**ORIGINAL COMBINED STAGE 1 AND STAGE 2 ROAD SAFETY AUDIT BY WYG
RAMSAY & CHALMERS DESIGNERS RESPONSE TO RSA
ORIGINAL NON-MOTORISED USER AND ACCESSIBILITY AUDIT BY WYG FOLLOWING RAMSAY &
CHALMERS DESIGNERS RESPONSE**

Proposed Residential Development, Deveron Road, Huntly

Combined Stage 1 & Stage 2 Road Safety Audit

Non-Motorised User and Accessibility Audit

Figure 2: Path alignment

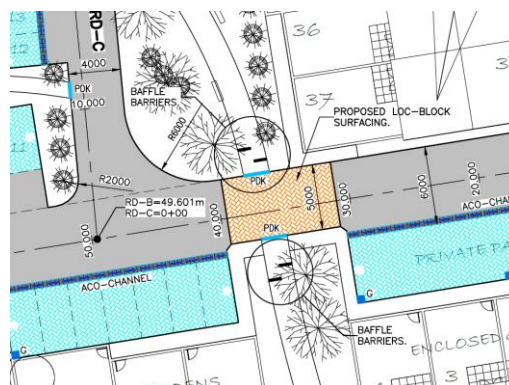
Location: Central footpath (Southern crossing)

Summary: Alignment likely to create difficulties for visually impaired pedestrians

The alignment of the paths between unit 4 and 37 do not align with each other and are staggered. This alignment will make it difficult to provide correctly aligned tactile paving and may create a trip hazard for visually impaired pedestrians (See Problem 2).

It is recommended that the paths be aligned to allow provision of tactile paving.

The central footpath have been realigned to be opposite one another.

Figure 1 – Service Bay

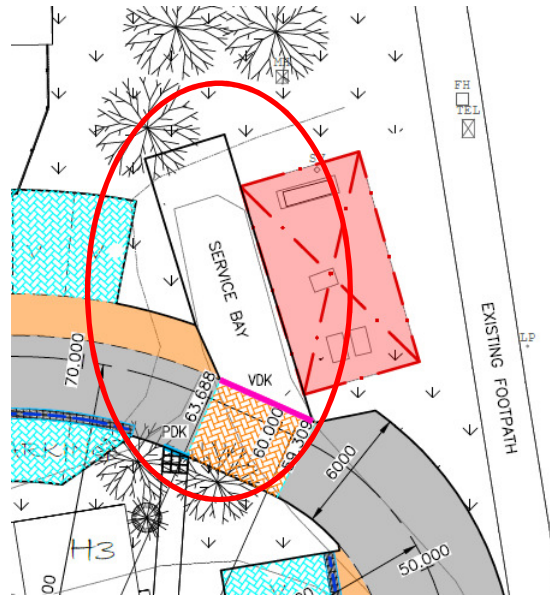
Summary: Service vehicles will require to either access the apparatus across the cycleway or park on the verge to the north.

The existing substation and pumping station located to the north east of the site currently have access from the south with an area for engineers to park while working on the equipment. The proposed scheme layout does not indicate an area for maintenance vehicles. This could result in vehicles driving on and obstructing the shared footway cycleway and risking collisions with pedestrians and cyclists.

It is recommended that provision is made to allow safe access to the equipment for service vehicles.

A service bay has been incorporated into the layout to accommodate maintenance vehicles without obstructing vehicles on the proposed access road.

Figure 2 – Proposed Crossing Point

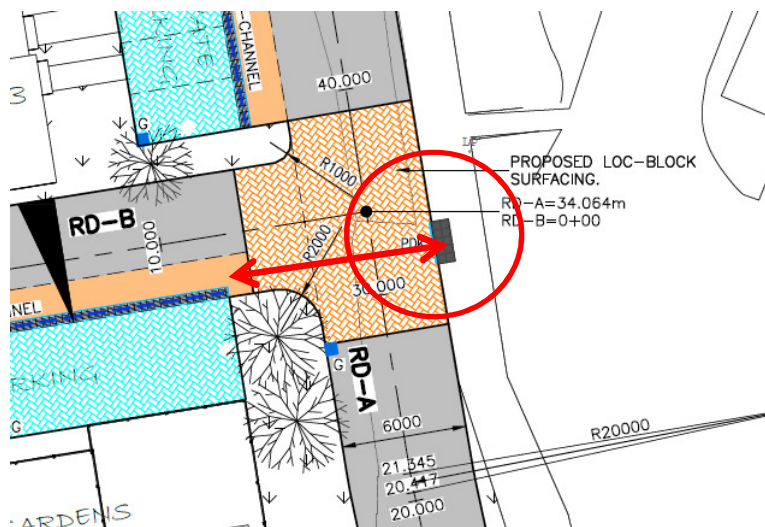
Summary: Insufficient provision of dropped kerbs and tactile paving

Dropped kerbs have been indicated on the central pedestrian path, however no tactile paving is proposed. In addition to this, no dropped kerb access is shown to allow users from the development to access the shared footway/ cycleway to the east of the site. A lack of these facilities can lead to an increased risk of accidents for pedestrians and cyclists accessing or crossing at these facilities, particularly those with visual or mobility impairments.

It is recommended that tactile paving be provided at all crossing points within the site and dropped kerbs be provided to allow access to the shared footway/ cycleway.

Tactile paving has been incorporated into the layout. A proposed crossing point has been incorporated from the existing shared footway / cycleway to the shared surface road.

Figure 4 – Shared Surface Zones With Contrasting Surface Finish

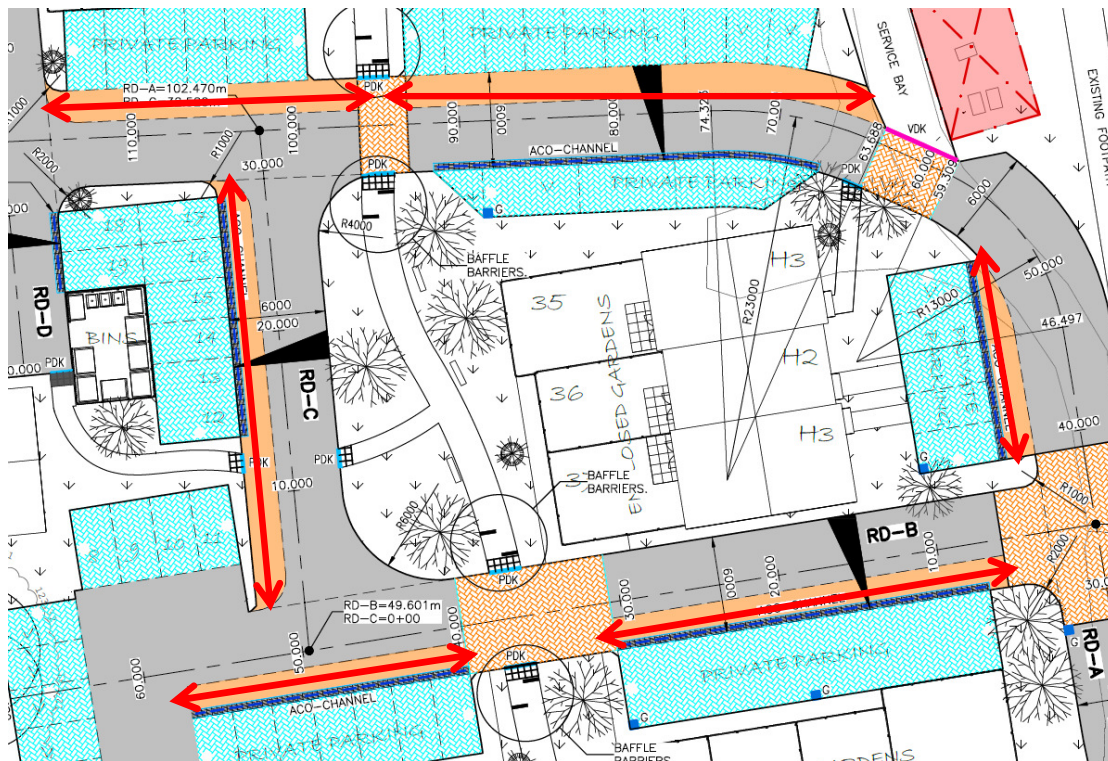
Summary: Insufficient safe footway access to properties

The site has been designed with path provision from the north to the south of the site with what appears to be a shared use road layout where pedestrians are to walk on the carriageway to access the properties with some narrow paths providing some connections.

The Audit Team are concerned that the layout will be difficult to navigate for visually impaired pedestrians and also that with the surfacing of the carriageway, it will not be clear to them that this is a shared use road.

It is recommended that either footpaths be extended to provide a fully connected network through the site or a full block-paved surface be provided with contrasting surface colours to indicate safe pedestrian areas and aid with navigation for partially sighted pedestrians.

The shared surface areas will have HRA with red coated chippings to aid with navigation for partially sighted pedestrians.

Figure 6 – Location Of Diagram 674 and 675

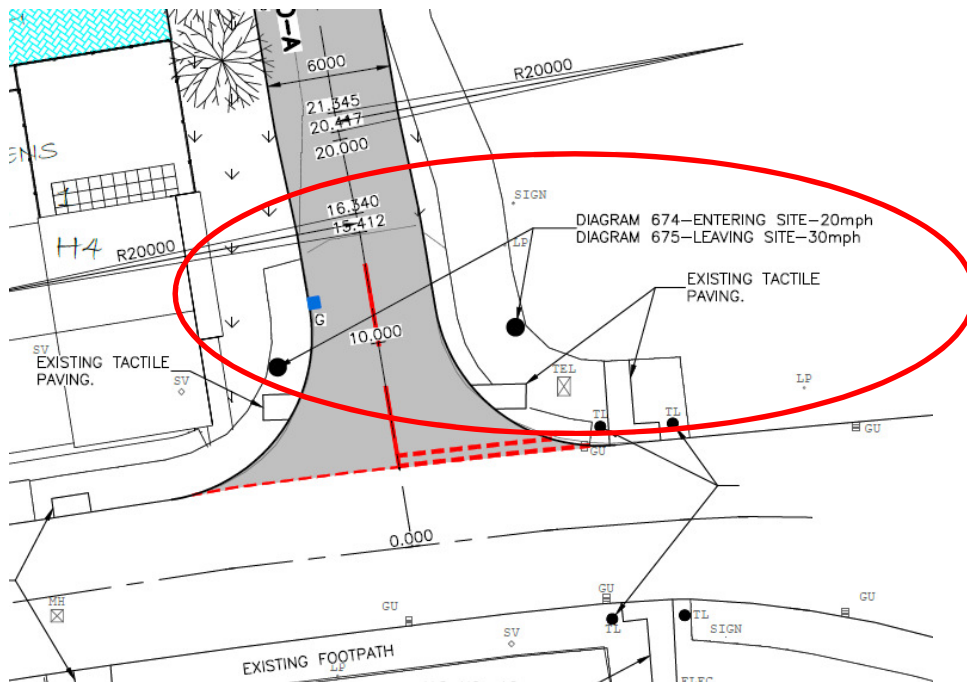
Summary: Insufficient signing of speed limits or traffic calming measures

No details are shown at this stage as to a proposed change in speed limit at the access junction. As traffic calming is proposed in the form of build outs and also with a shared use road layout, it is expected the design would propose a speed limit of 20 mph. This could create confusion and result in vehicles travelling at excessive speed, putting pedestrians at risk of being struck within the site. It was noted during the site visit that the site to the east was signed as a 20 mph zone and the site to the north also as 20 mph with home zone signing (See Figure 3).

It is recommended that 20 mph zone signing be provided at the site access.

Signs to Diagram 674 and 675 have been incorporated into the layout.

Figure 7 – Location Of Give Way Markings

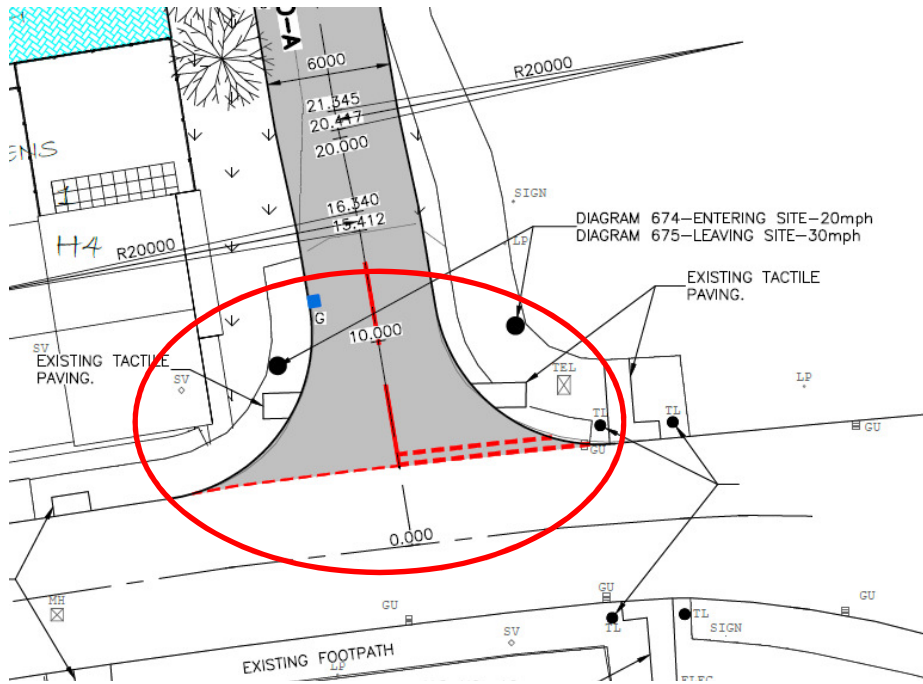
Summary: Insufficient junction priority markings

No road markings are proposed at the site access junction. With no priority markings at the junction, there is a risk that drivers will fail to give-way, resulting in collisions.

It is recommended that give-way markings are provided at the access junction.

Give way markings have been incorporated into the layout.

Figure 2: Missing pedestrian connections

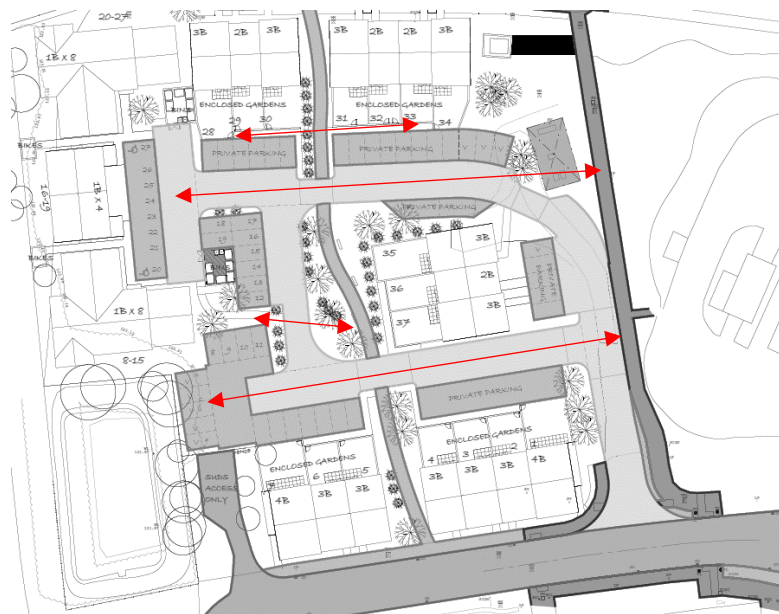
Summary: Insufficient pedestrian connections through the site

Description: While good connections are proposed through the site from north to south both through the site and to the east of the site, there are limited connections provided for users to travel west to east through the site. This would have an impact on those on the properties to the west if they want to join the footway to the east. The lack of formal facilities can result in pedestrians walking on unsuitable ground and can make navigation for visually impaired pedestrians difficult.

Action Recommended: It is recommended that either connecting east/ west footways are provided or a contrasting surface be used on the shared use road surface to aid pedestrian navigation.

Design Team Action Taken: The shared surface areas will have HRA with red coated chippings to aid with navigation for partially sighted pedestrians.

Figure 4: Pedestrian desire line

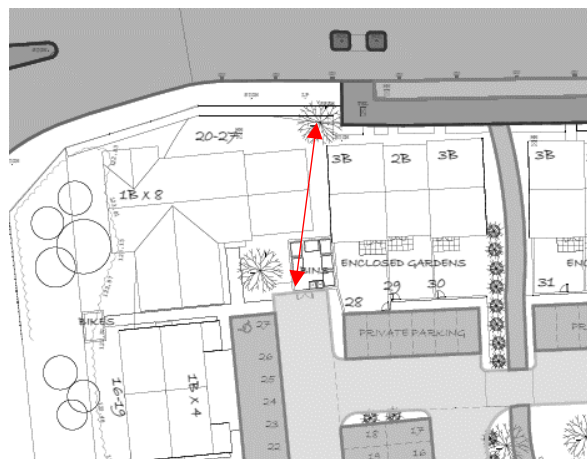
Summary: Potential pedestrian desire line

Description: There is a potential route from Devron Road to the properties to the west of the site that will likely be used by pedestrians as the more direct route.

Action Recommended: Provide a footway between properties 27 and 28.

Design Team Action Taken: There will be a hedge incorporated into the layout at the back of the footpath to assist with deterring pedestrians using the route between the flats and Plot 28.

The footway between Plots 30 and 31 provides adequate access to the existing A920 – Deveron Road footway.

Figure 5: Lamp Column

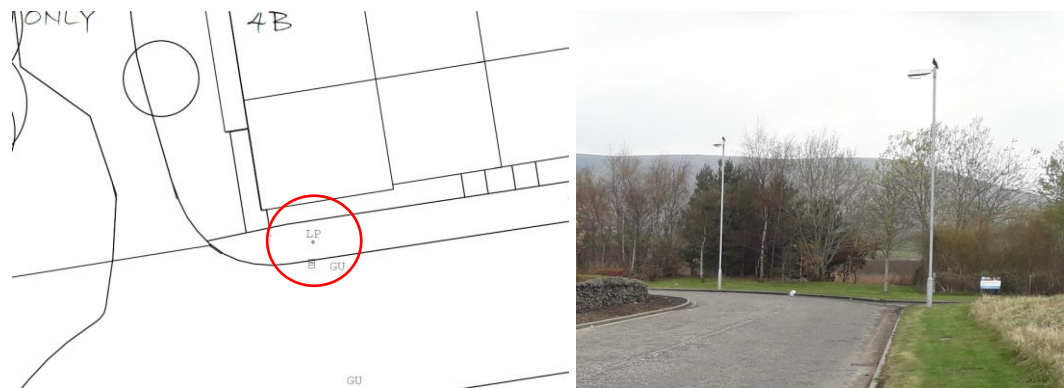
Summary: Lamp Column likely to obstruct footway

Description: There is a lamp column adjacent to property No. 7 that will be located in the centre of the footway and is likely to cause an obstruction to pedestrians, particularly those in wheelchairs or parents with buggies.

Action Recommended: Relocate lighting column to the rear of the footway.

Design Team Action Taken: The existing lighting column will be relocated to the rear of the footway. This will be incorporated into the street lighting design which will be carried out at detailed design stage.
